# Index 425-060 Back of Sidewalk Drainage

# **COMMENTS AND RESPONSES**

(Pipe Connection Not Shown)

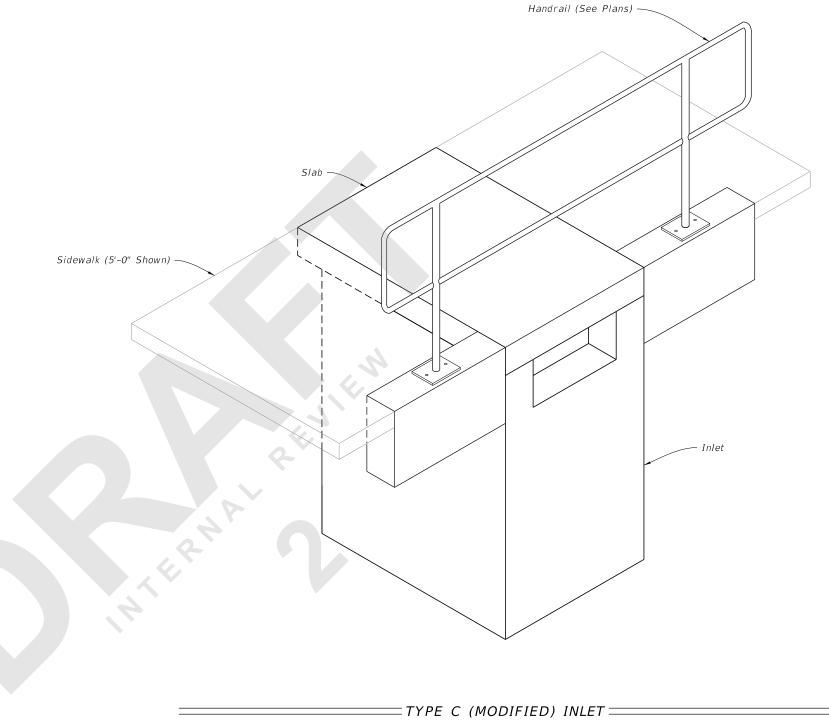
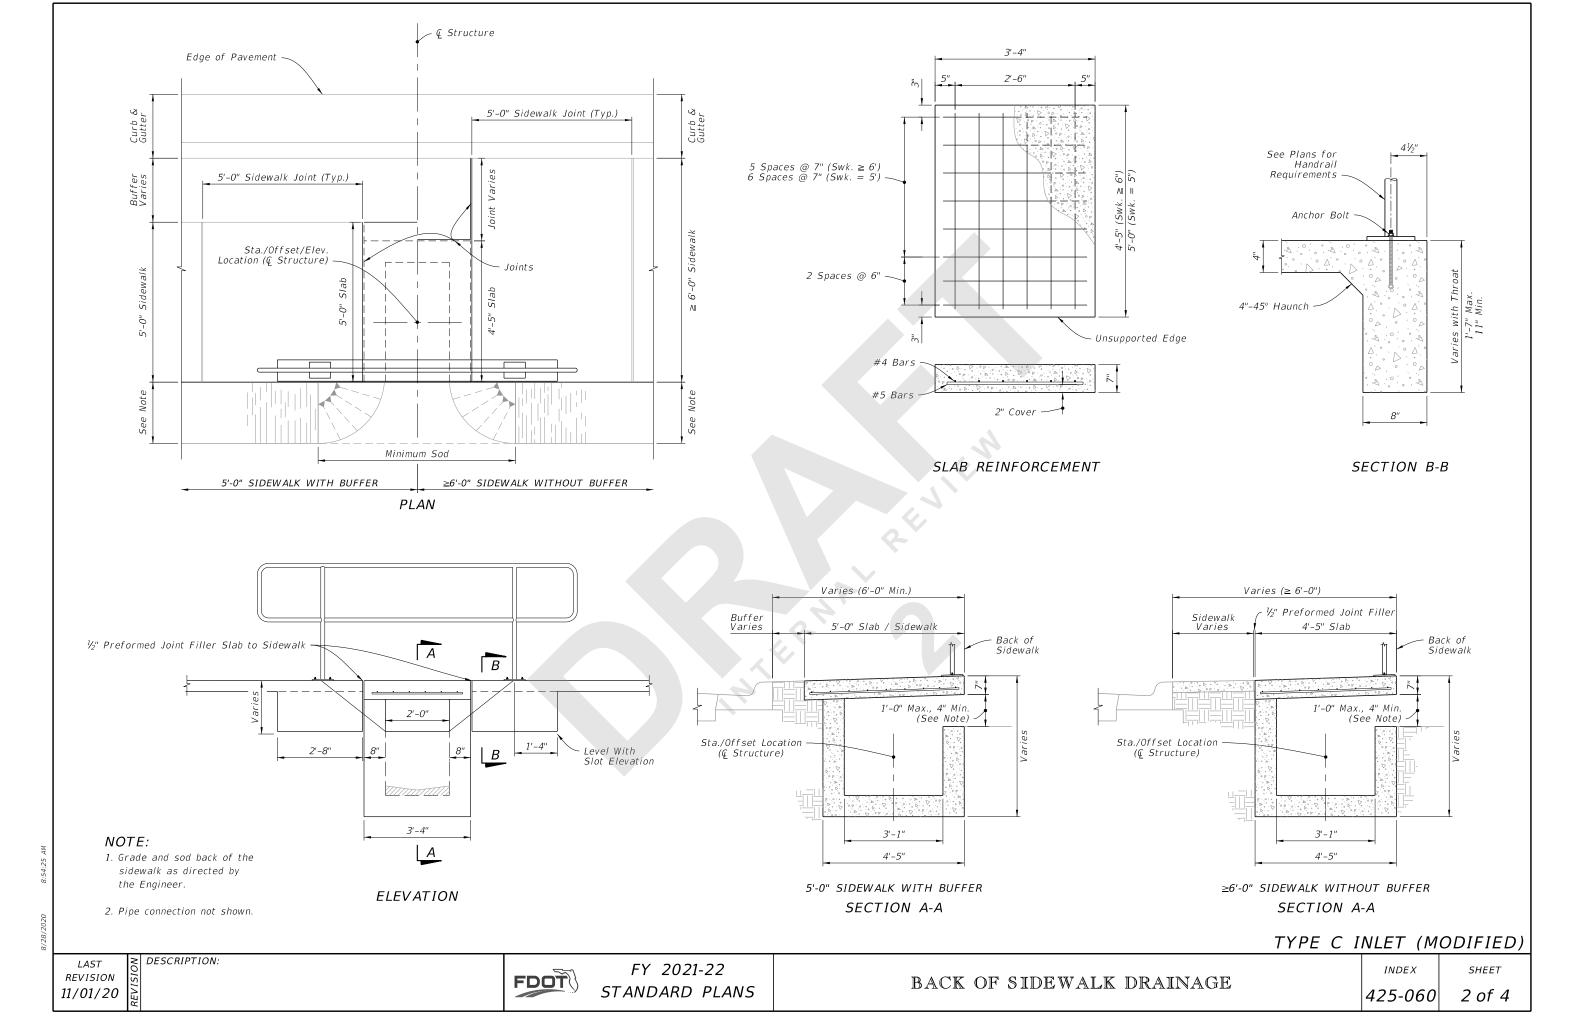
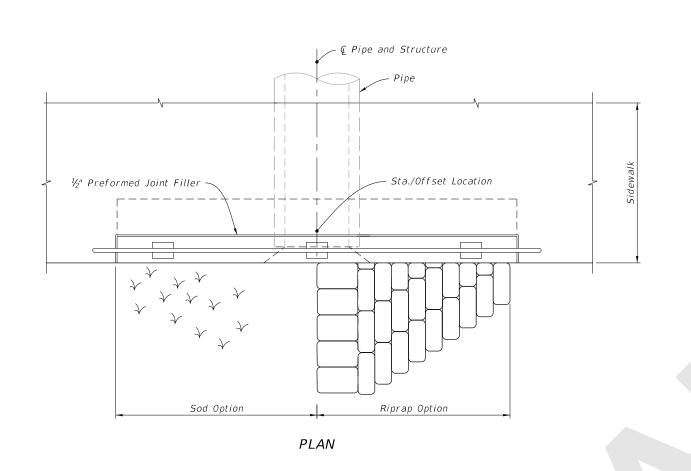
**COMMENT:** Can we remove the pipe from the back of sidewalk inlet standard plan? Pipes aren't shown on other inlets and I mostly see the pipe running longitudinally and not laterally as shown in the index, 425-060.

**RESPONSE:** Agreed.

**Change made to Index:** The pipes were deleted from the inlet details on sheet 2 and a note was added that states "Pipe connection not shown".

SPECIAL CONCRETE ENDWALL

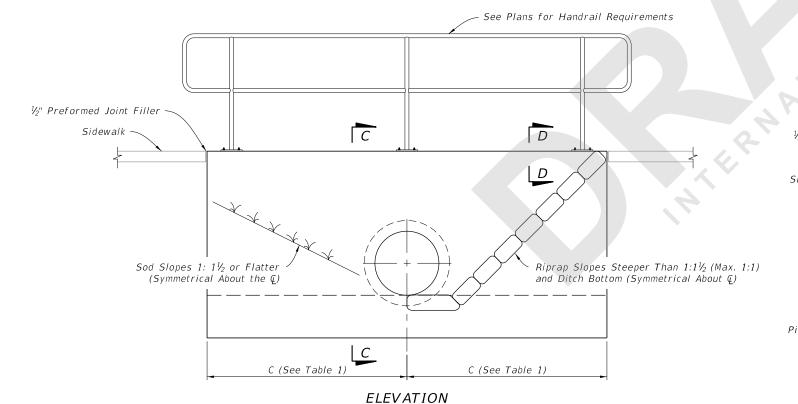
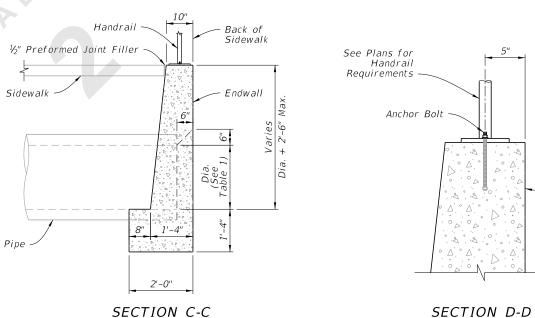
**COMMENT:** Sheet 3, Table 1 widths: Considerations should be made for wider wall limits due to slope tie-in with adjacent sidewalk. Current worst-case scenario of 4'-6" depth (2'-6" max + 24" diameter pipe) would require 6'-9" width to meet the back of sidewalk elevation at 1:1.5 slope with the sod option. Similar with other pipe diameters.

**RESPONSE:** These are values that were included in the existing index. This will be further investigated for the next cycle of Standard Plans updates.

No change to Index at this time
